Access Compliance Report Public Rights-of-Way (Curb Ramps)

Main Street: RAVENCREST_RD		Cross Street: NEWPORT_AVE		Location:	S
ADA ID: RPRK211228150131	Ramp Type: Type 4 - Parallel	Initial Pass/Fail: Fail	Overall Compliance: No	Severity Score:	2
Codes/Mitigation Info/Possible Solution			Field Measurements/Component Compliance

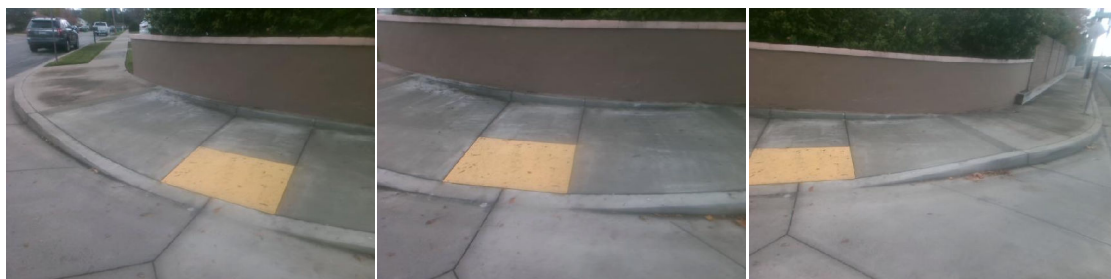
R304.5.3, STD 1115

Remove & Replace Curb Ramp With Two New Directional Ramps or Equivalent.
